CALIFORNIA  
**HIGHLAND ESTATES**  
**LOT 11 IMPROVEMENT PLANS**  
**EROSION CONTROL PLANS**  
 SAN MATEO COUNTY

**Date: April 25, 2016 (Revised – 8/9/17)**

**Re: Planning Comments on Lots 9-11**

**From: Camille Leung, Senior Planner**

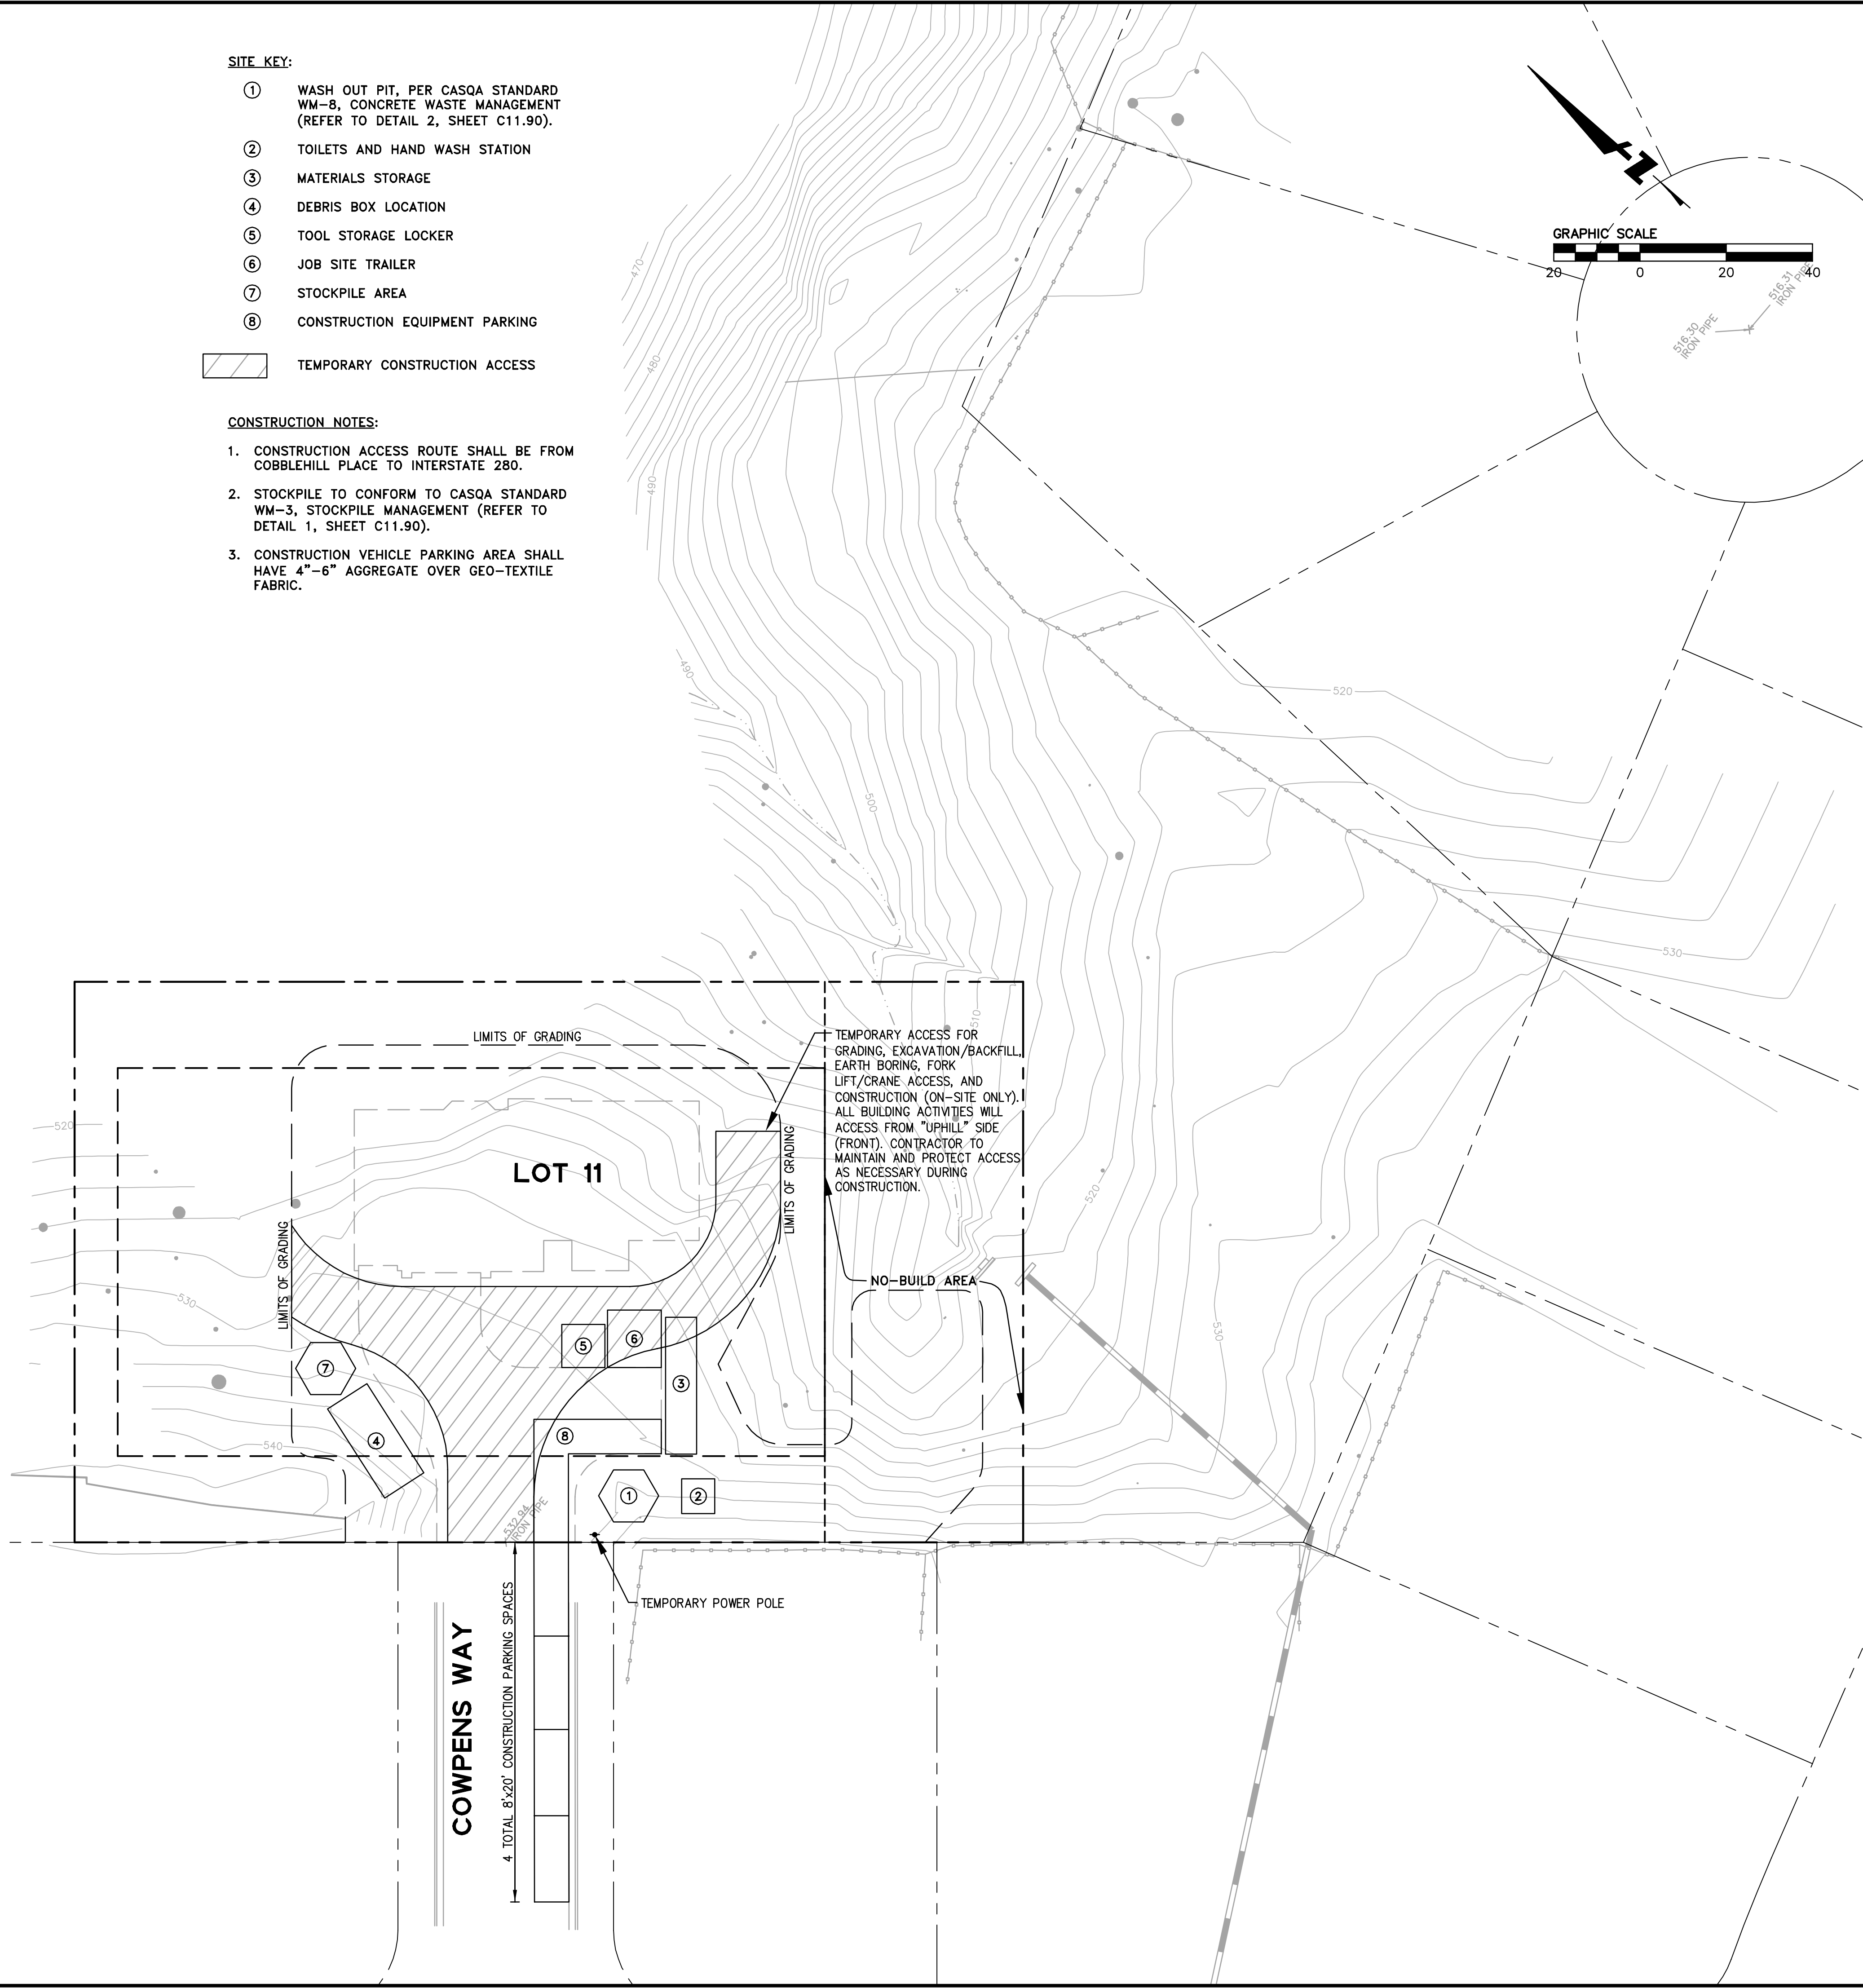
- a. Show location of office trailer(s), storage sheds, temporary power pole, scaffold footprint, and other temporary installations on the plans. Show how they will be accessed and show protection of the access routes. –Lot 11: Move stockpile to a location within grading limits

**LOT 11 GRADING AND RETAINING WALL EROSION CONTROL PLAN**  
 SCALE: 1"=10'

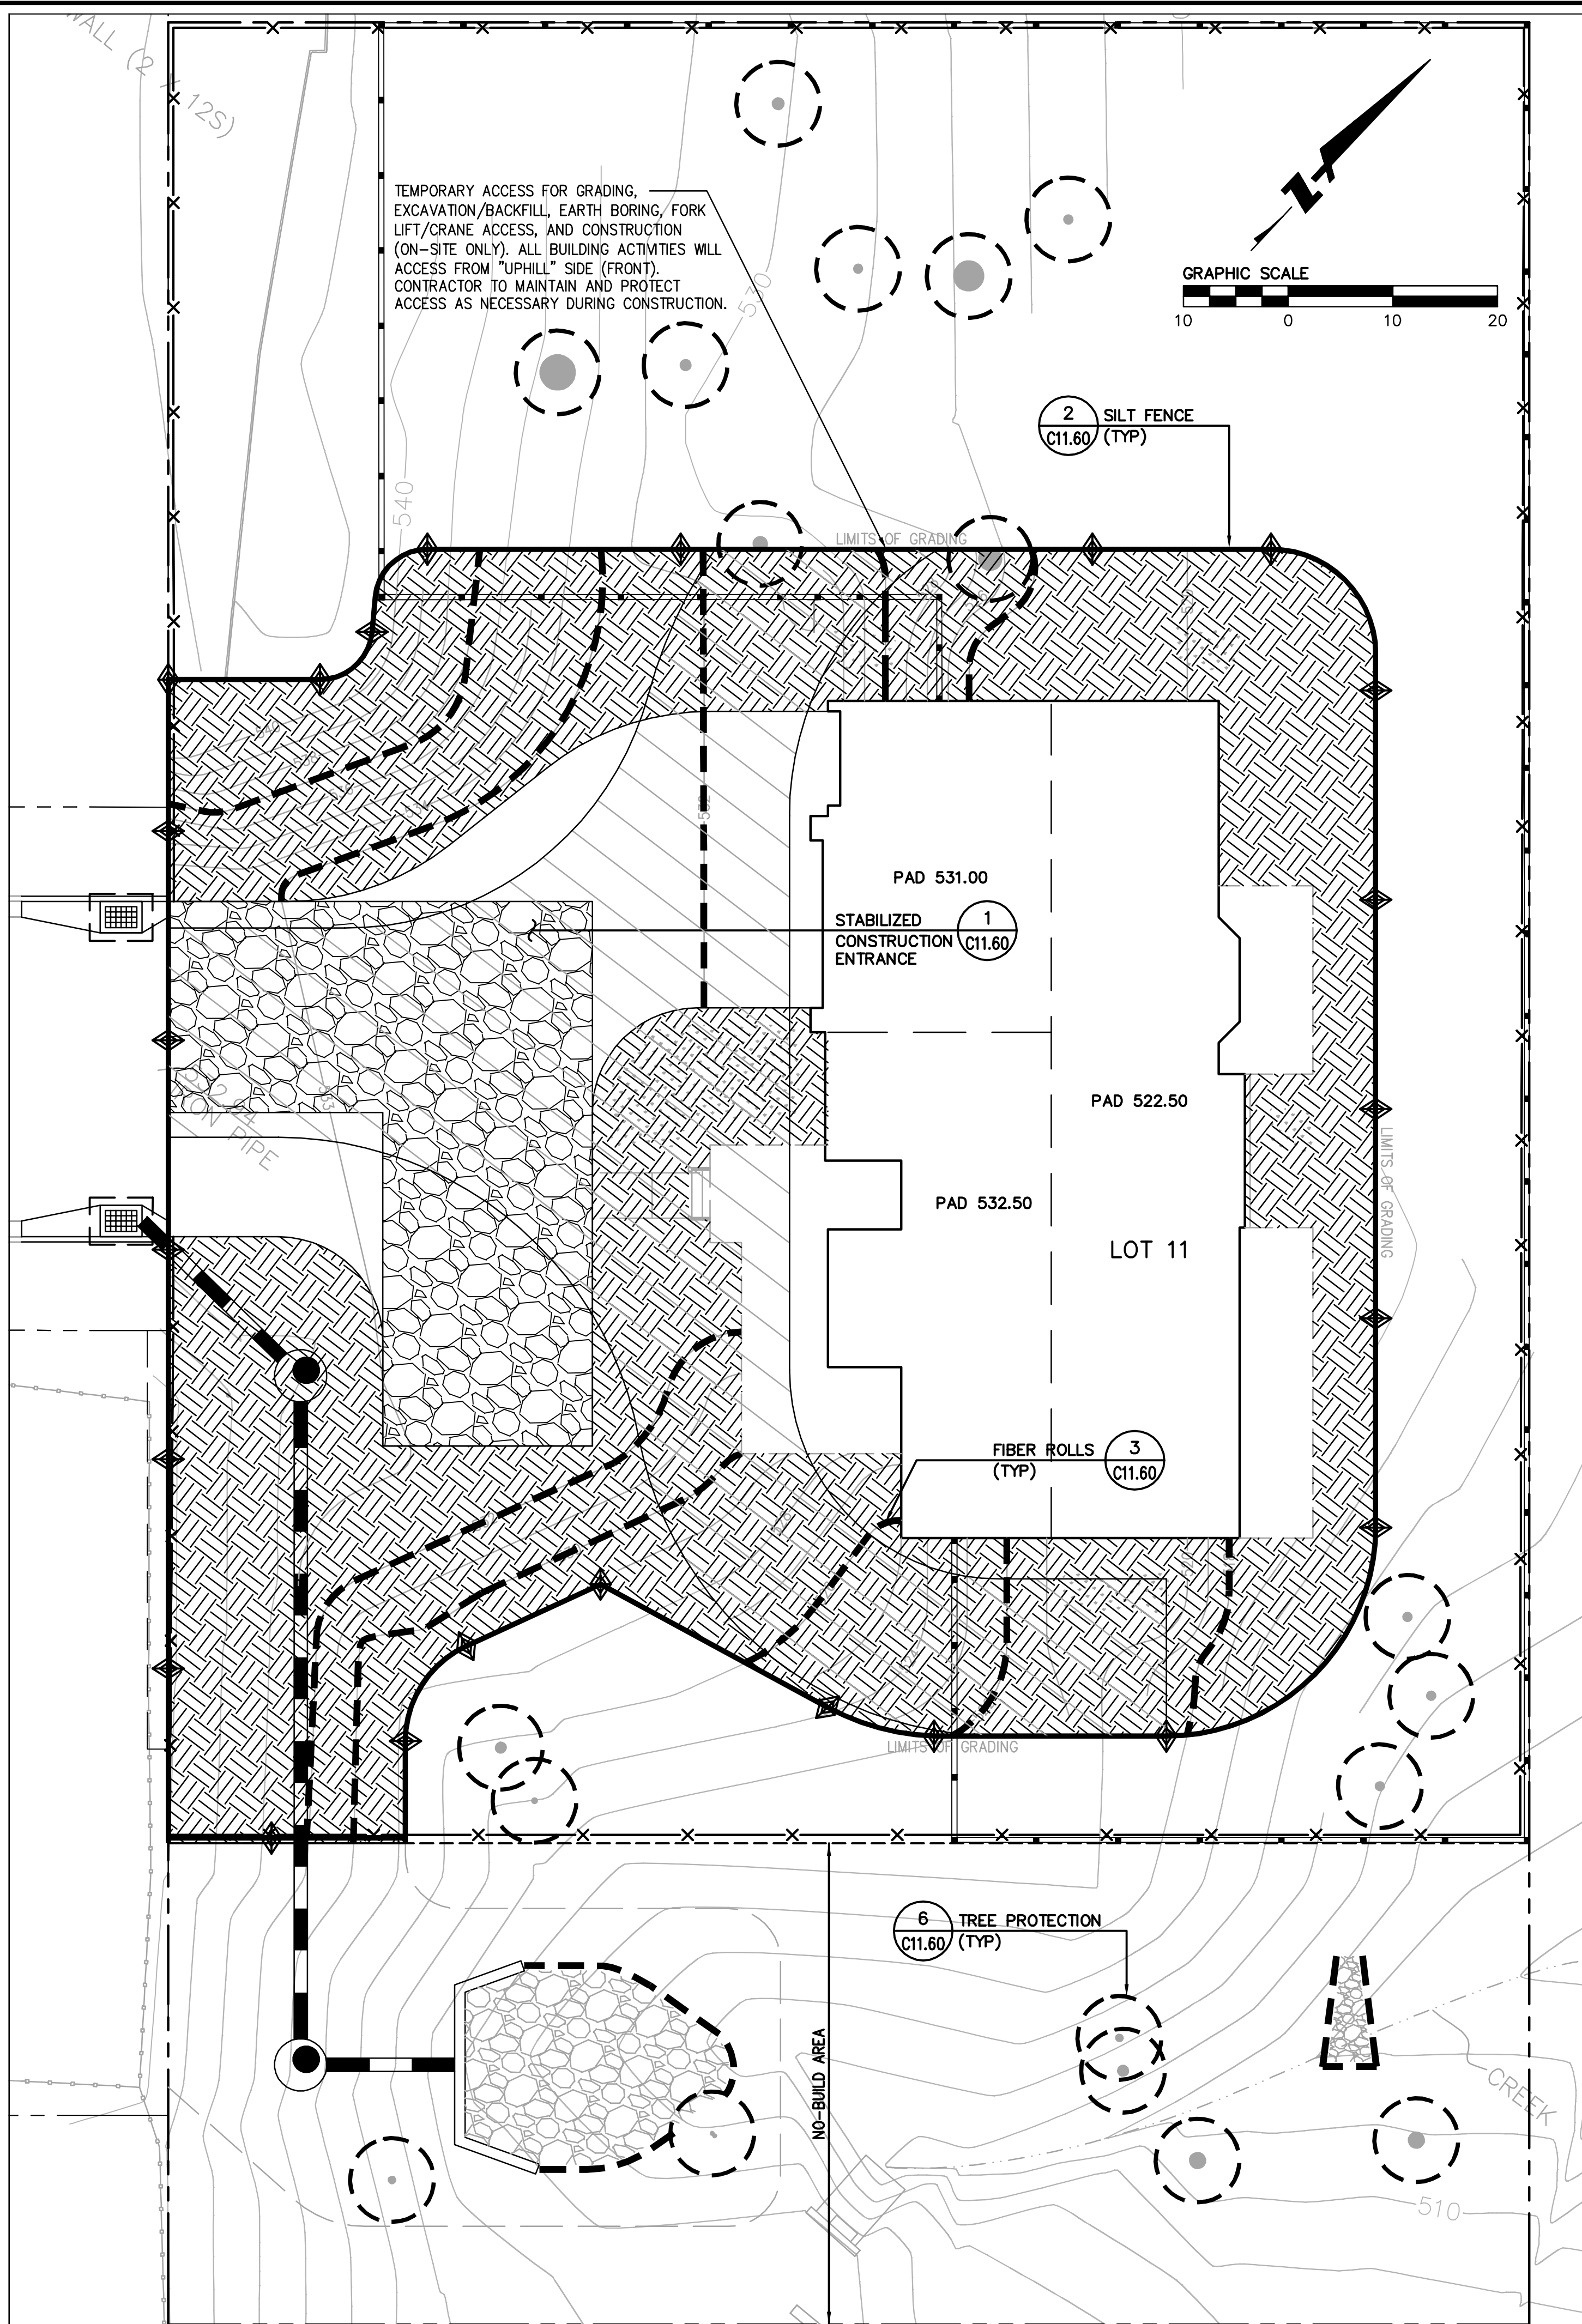
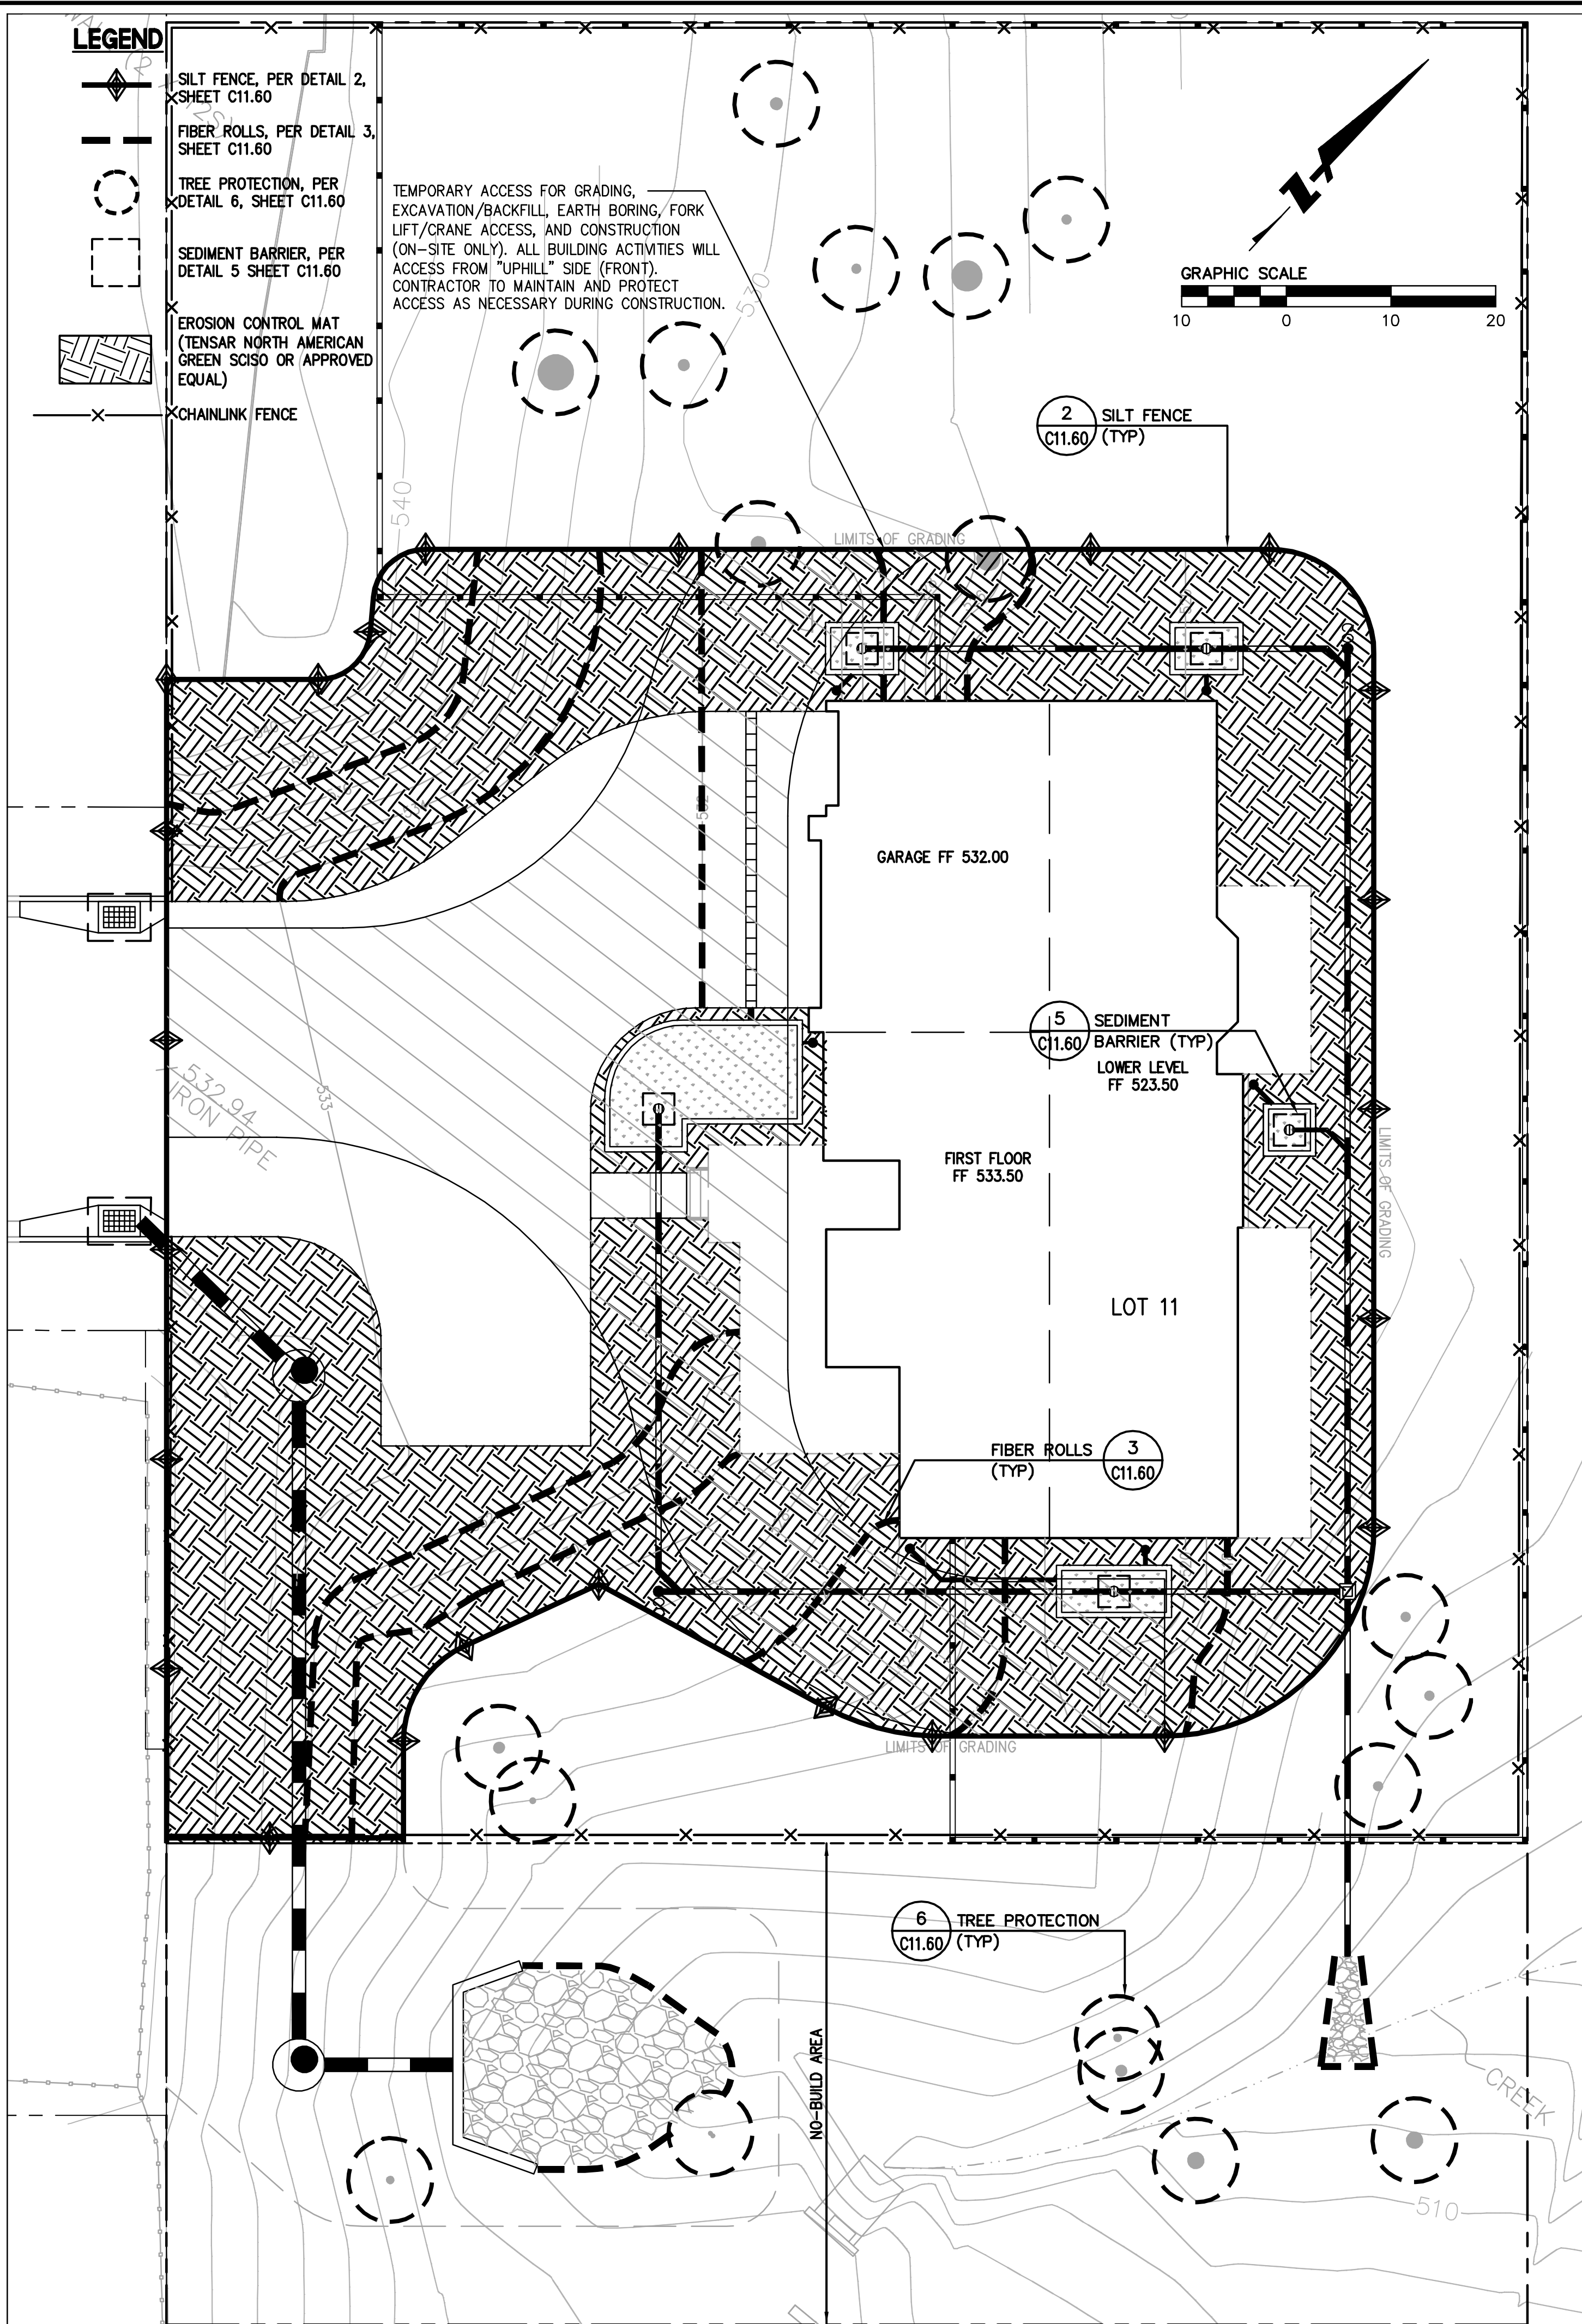
- c. Chainlink fencing at borders of conservation easement and along perimeter with no-build areas
  - d. On the Grading and Retaining Wall Erosion Control Plan, Show all access roads/ramps used for excavation/backfill, earth boring, fork lift/crane access (second floor construction). For unpaved routes, use ridges running diagonally across the road that run to a stabilized outlet.

TEMPORARY ACCESS FOR GRADING, EXCAVATION/BACKFILL, EARTH BORING, FORK LIFT/CRANE ACCESS, AND CONSTRUCTION (ON-SITE ONLY). ALL BUILDING ACTIVITIES WILL ACCESS FROM "UPHILL" SIDE (FRONT). CONTRACTOR TO MAINTAIN AND PROTECT ACCESS AS NECESSARY DURING CONSTRUCTION.
